AGENDA
CITY OF GLENWOOD SPRINGS
Planning and Zoning Commission
Regular Meeting
SEPTEMBER 22, 2020
Council Chambers, First Floor
101 W. 8TH STREET
6:00 PM

Date: September 22, 2020
To: Planning and Zoning Commission
From: Emery Ellingson, Planner I
Subject: #43-20– 820 Bennett Garage Variance

Date: September 22, 2020
To: Planning and Zoning Commission
From: Trent L. Hyatt, Senior Planner
Subject: #15-20 – Preliminary Plat, Oasis Creek Tract A Subdivision

Revised Site Plan

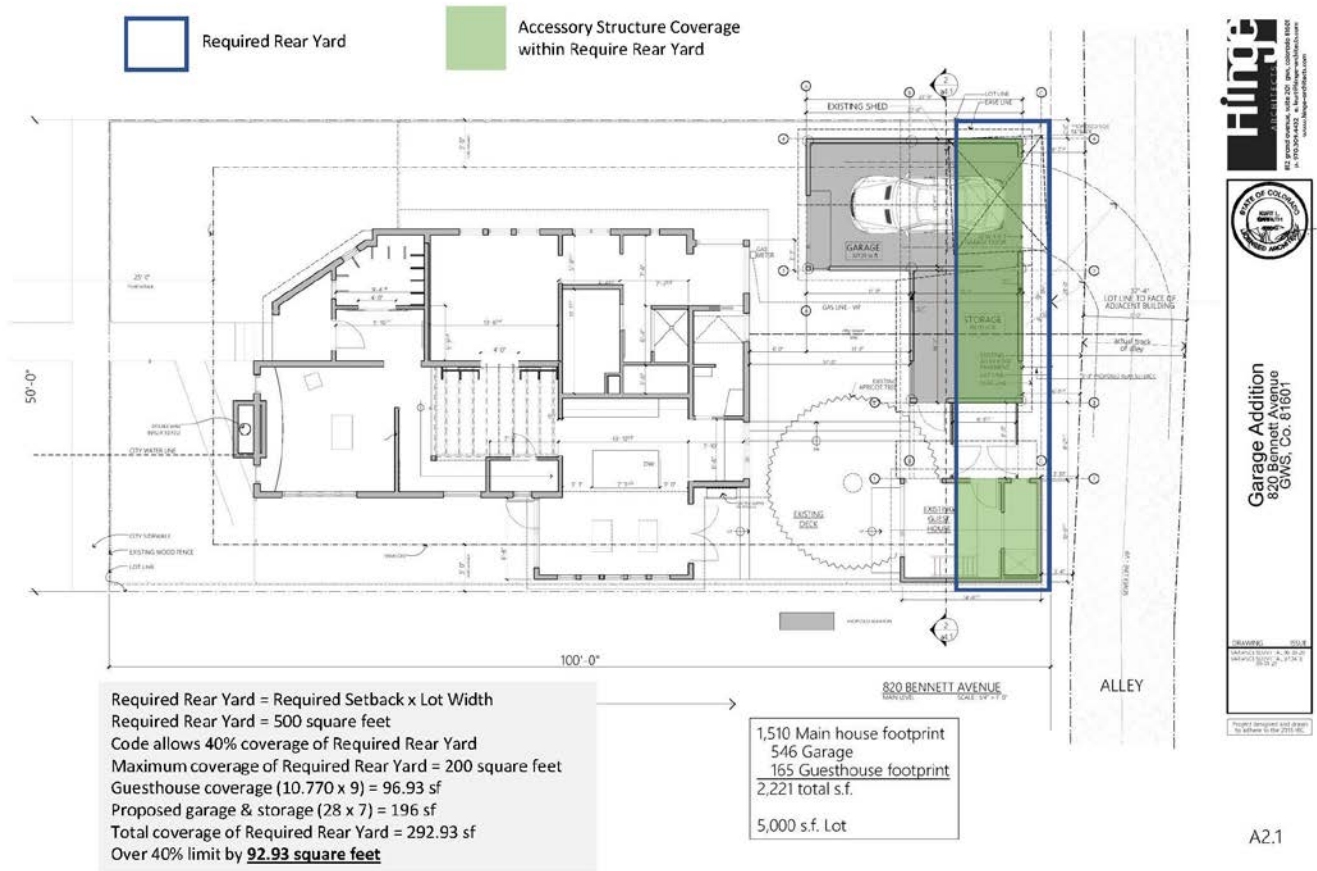
The variance requested is not the minimum variance that will afford relief of the subject standards of the Code. As indicated in the site plans, there is a 6.0' gap between the proposed garage and the existing house. Standard fire separation per Building code is 5.0' and an accessory building may be located at an even closer distance if following necessary Building Code requirements. The owner could locate the proposed detached garage closer to the house, consider a different alignment, or consider an attached garage. These options could result in a smaller encroachment into the required rear yard setback.

The revised designs cover 292.93 square feet of the 500 square foot Required Rear Yard. This is a 59% coverage, which includes the existing guest house. Staff does not find that strict application of Code standards would produce undue hardship as the request for relief from code is not due to physical site constraints but rather applicant's preference for use of available space and existing use of the property.

The variance requested is not the minimum variance that will afford relief of the subject standards of the Code. The applicant revised the designs to bring the total Required Rear Yard coverage down to 59% from 70%. However, due to the proposed project configuration, scale, and existing preferences for use of the property, staff has determined that this request is not the minimum variance that would relieve subject standards of Code. Increasing the rear setback, reducing storage space size, reconfiguring storage space size, or removing storage space would all be methods to minimize the variance request. If applicant reduced Rear Yard coverage to 200 square feet or less, this variance would not be required.

W/WW Comments

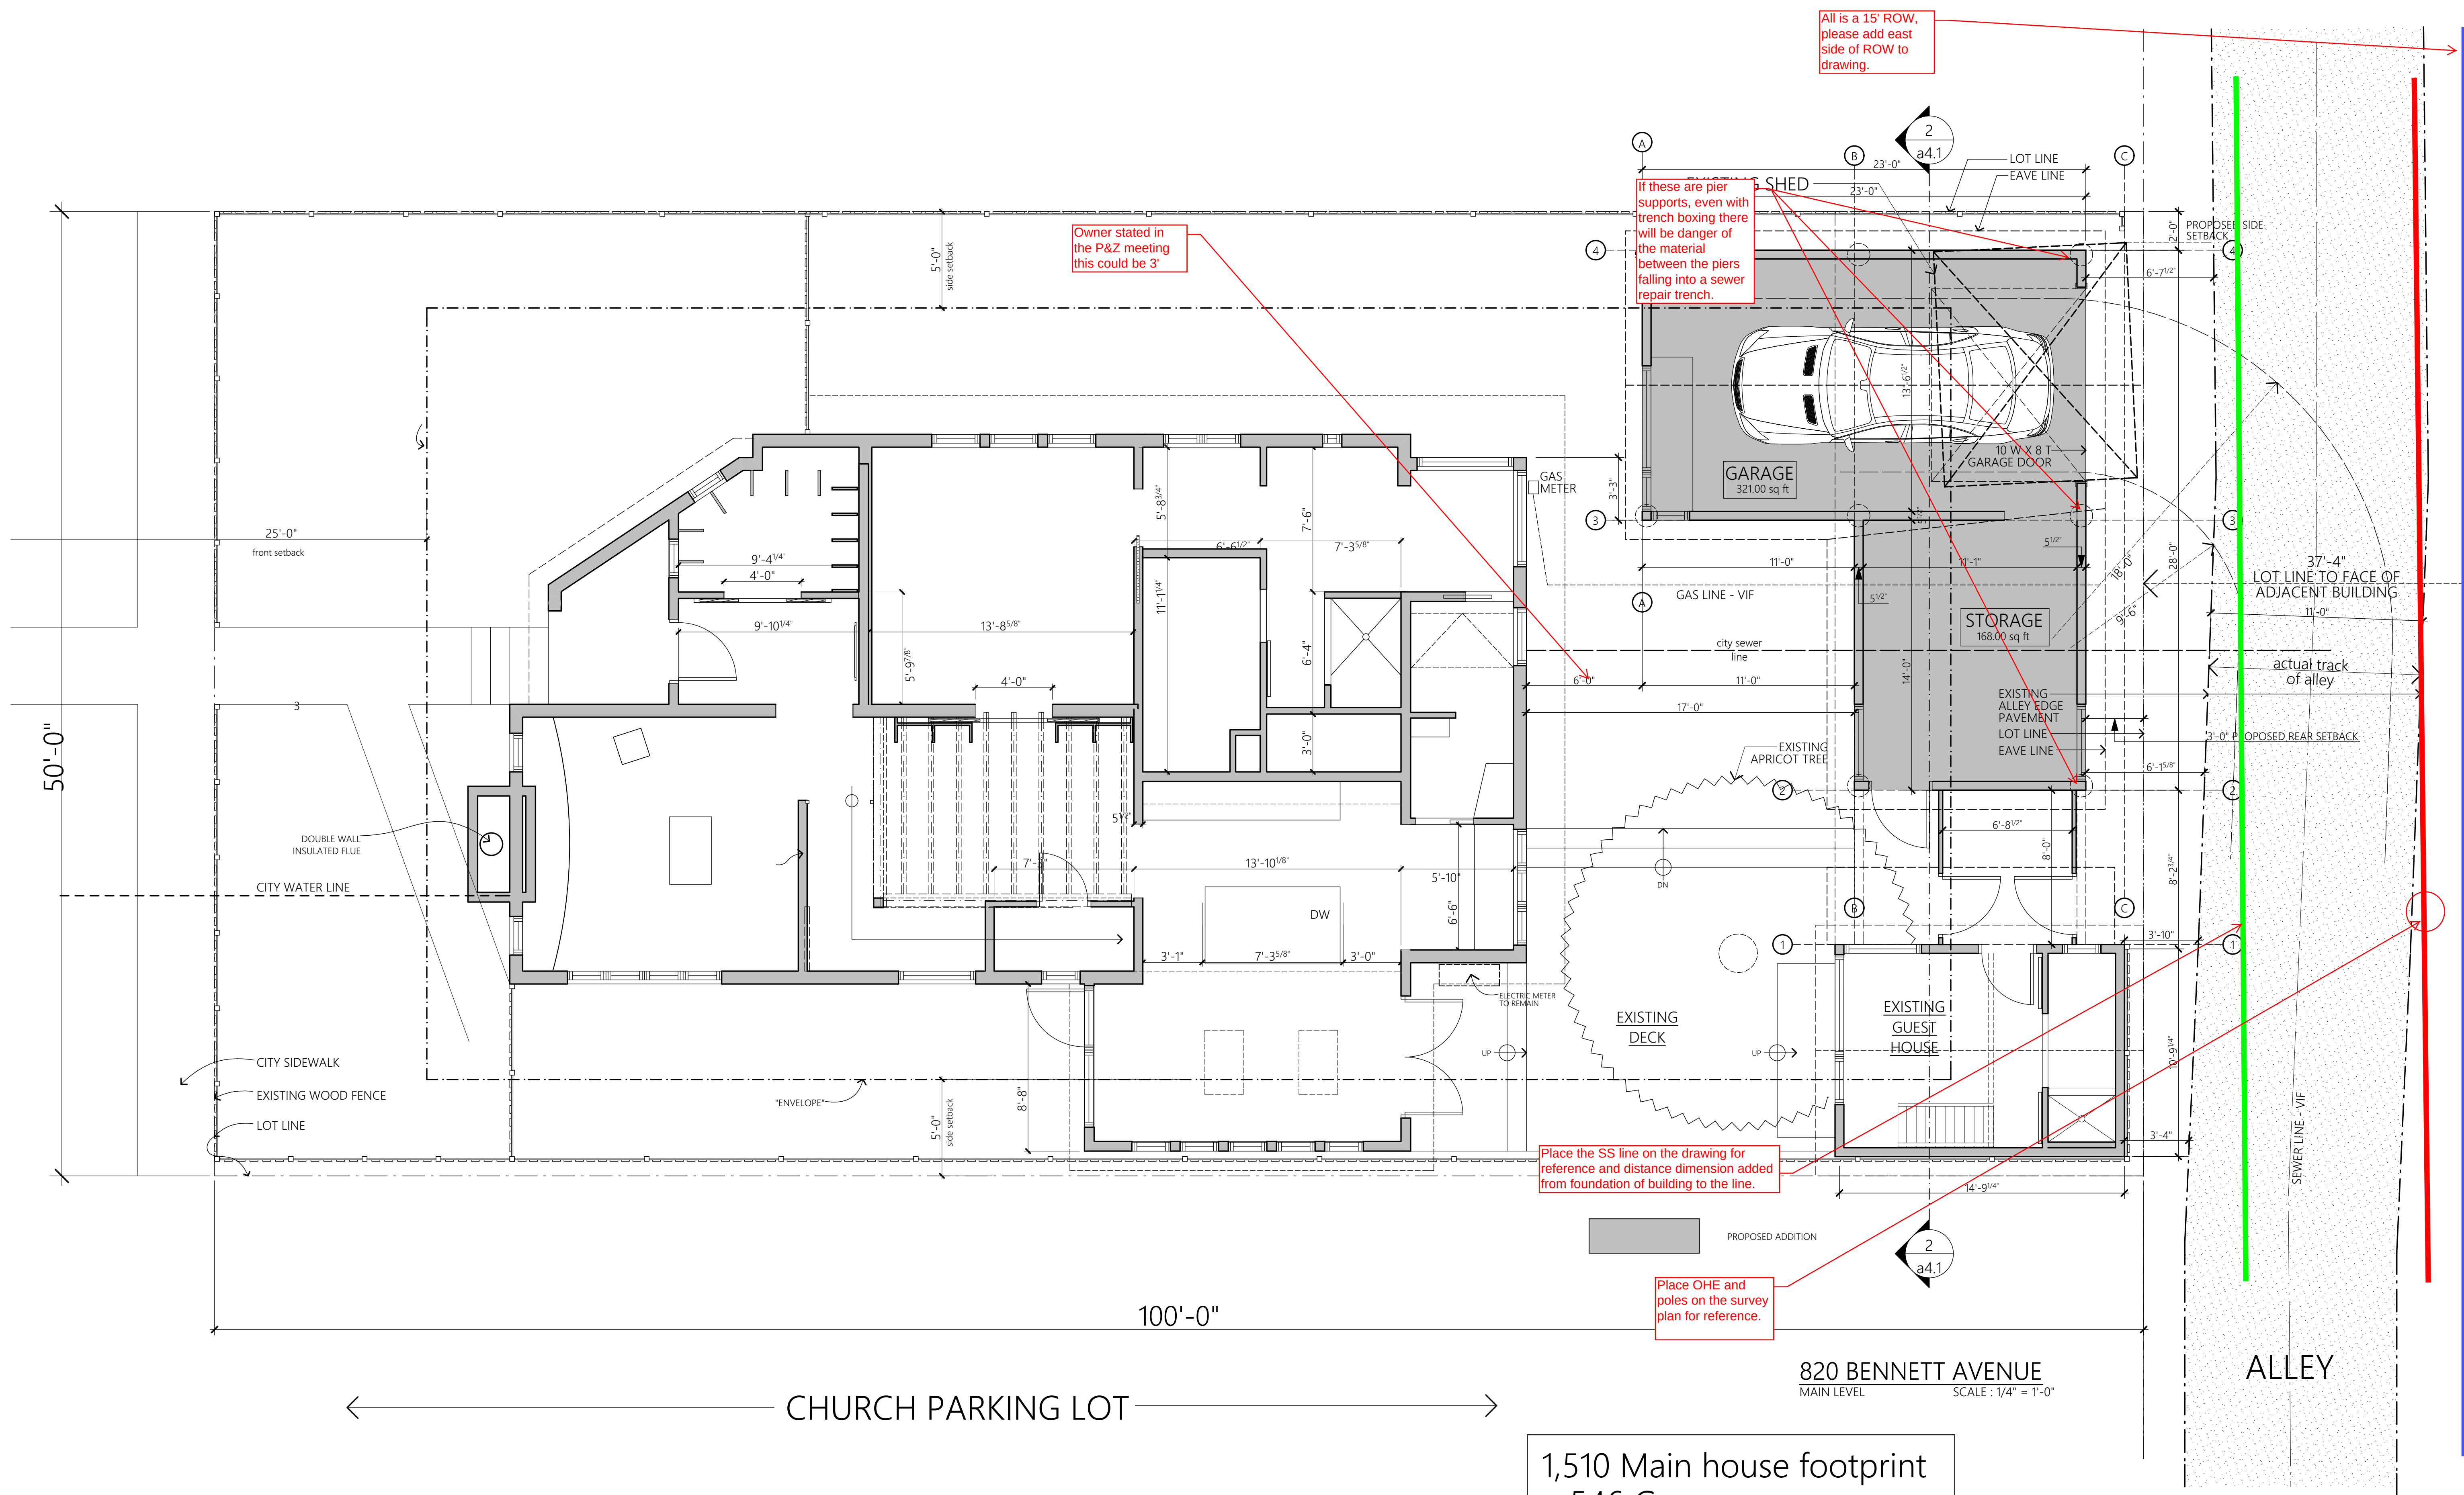
With the setback proposed at 1' off of the alley doing a major excavation in the alley to do a sewer main repair could cause all sorts of potential problems.

- Stabilization of a trench
- Protection of the proposed structure adjacent to a trench.
